Development Review Division

DATE: March 4, 2021

SUBJECT: SP20-081 New Horizon Daycare Site Plan – Planning Review 2

PHOTOMETRIC SITE PLAN

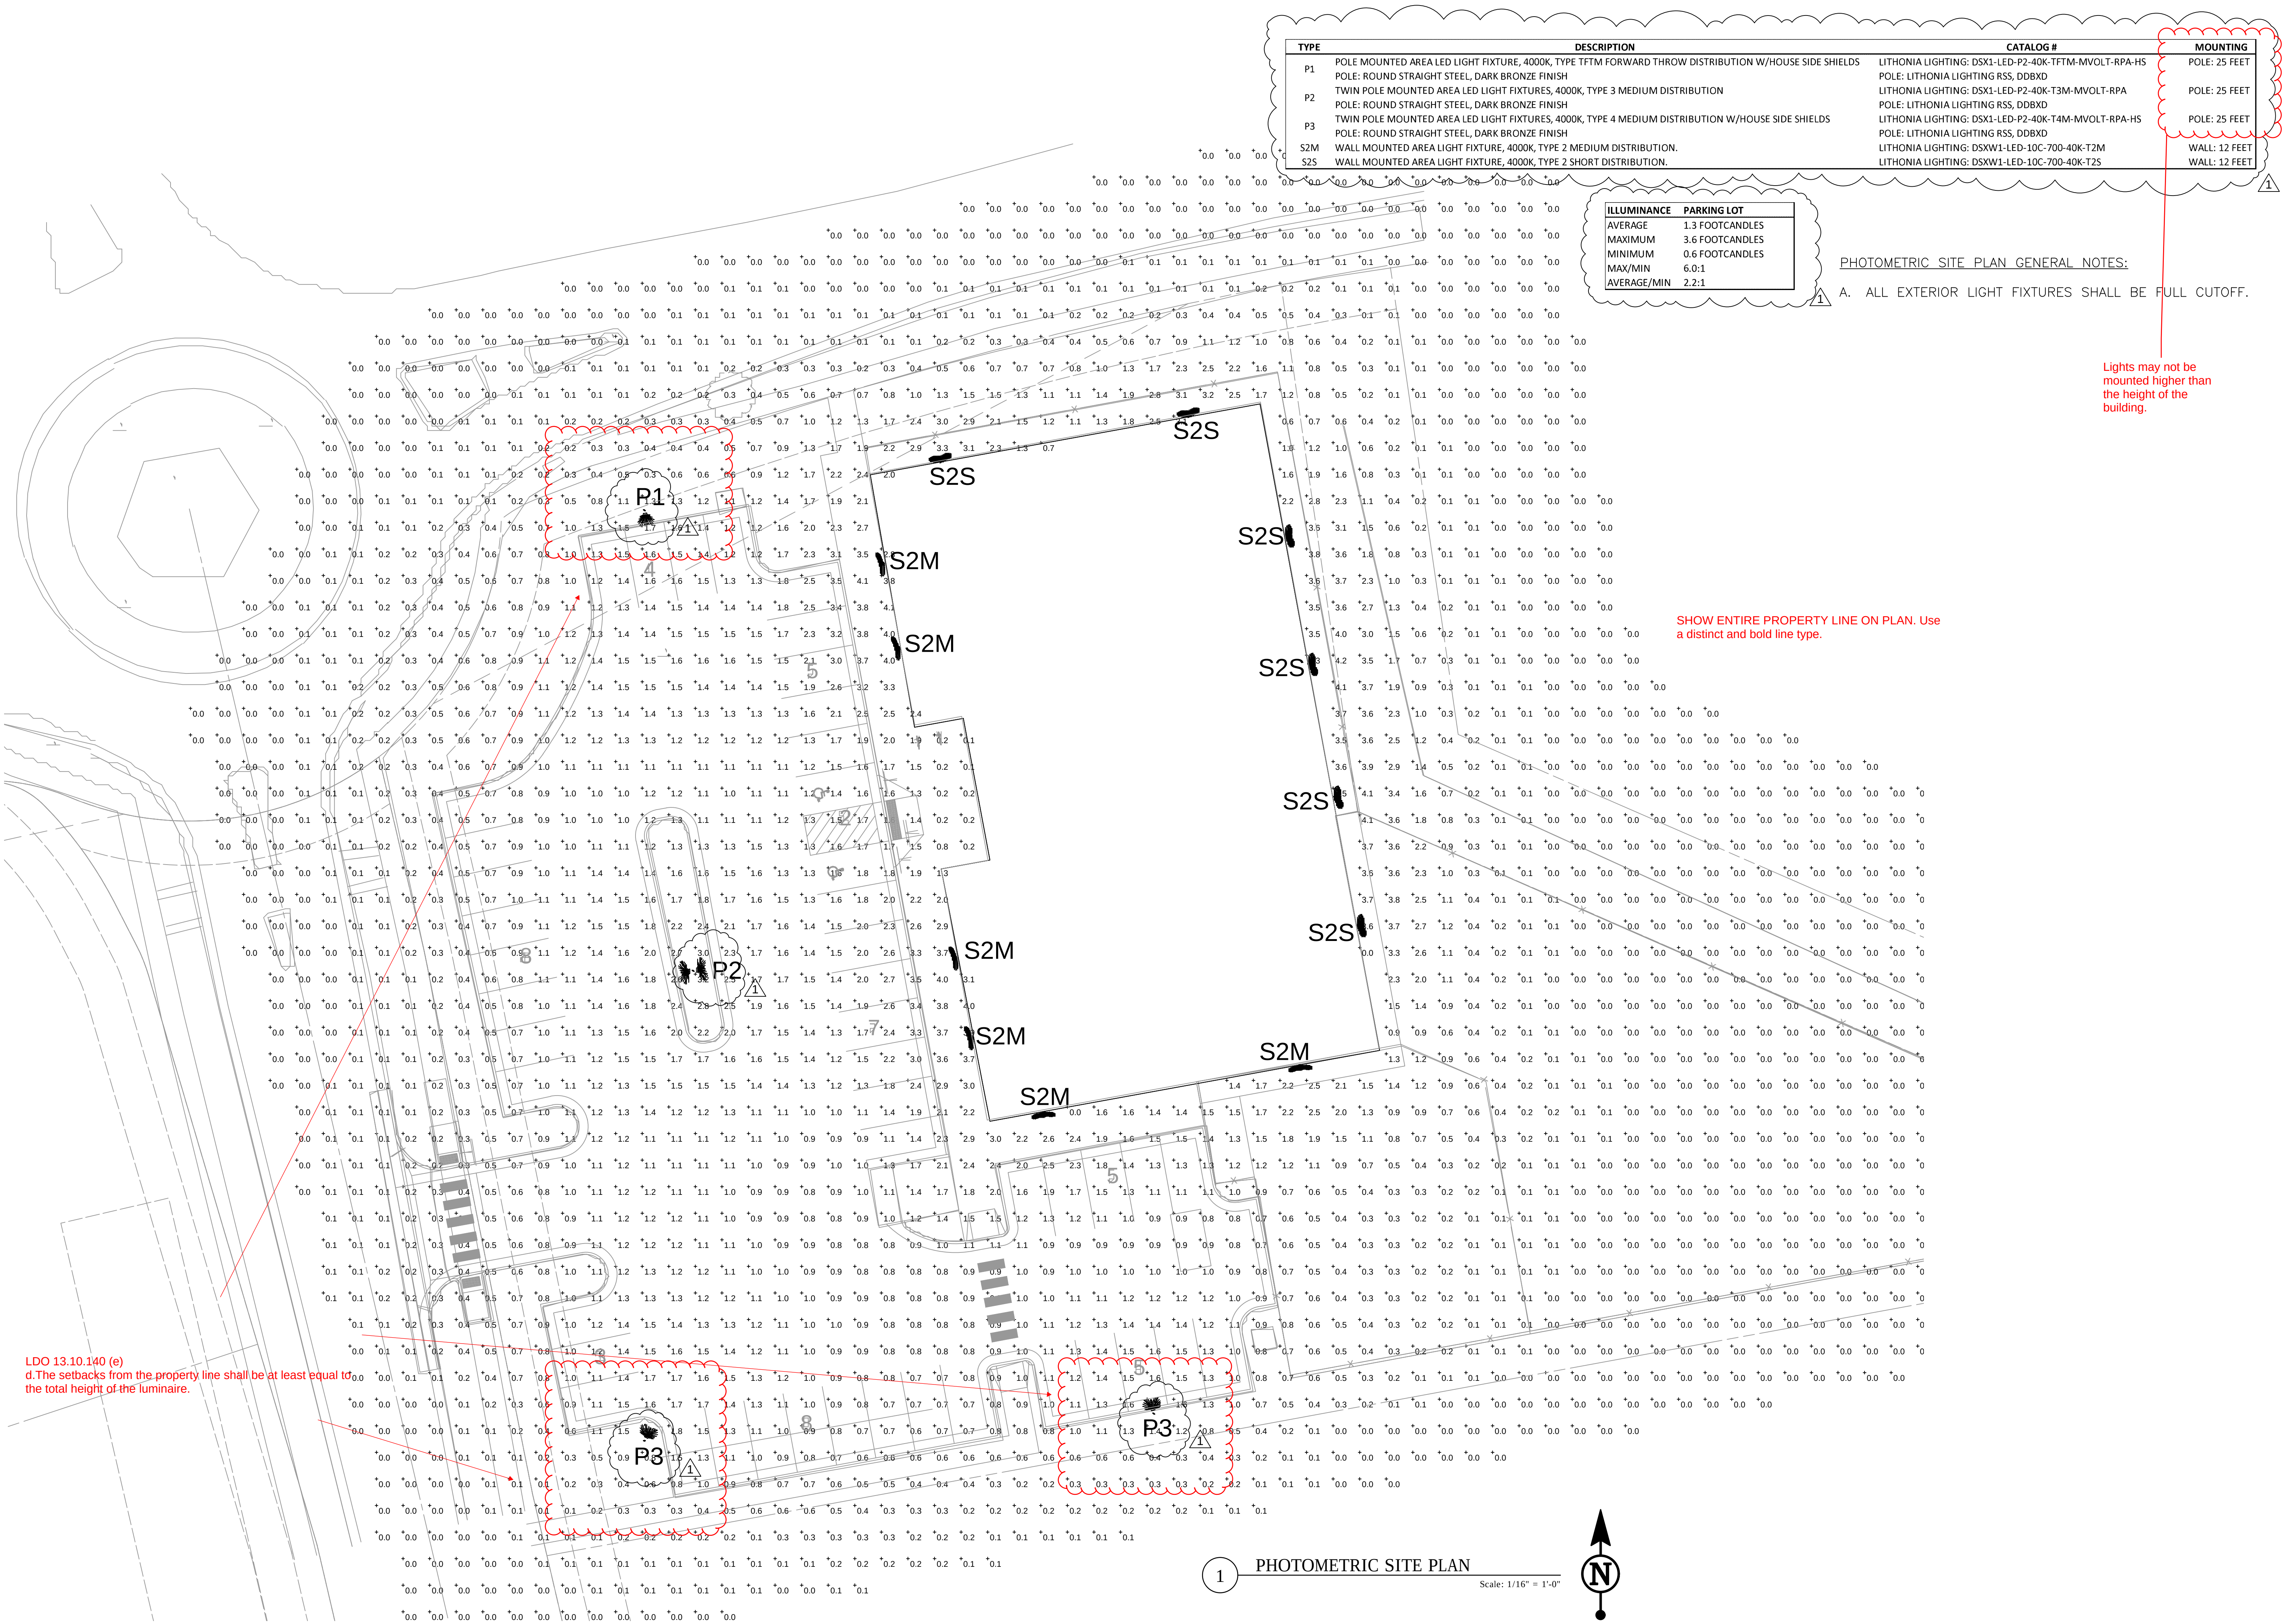
SHOW ENTIRE PROPERTY LINE ON PLAN. Use a distinct and bold line type.
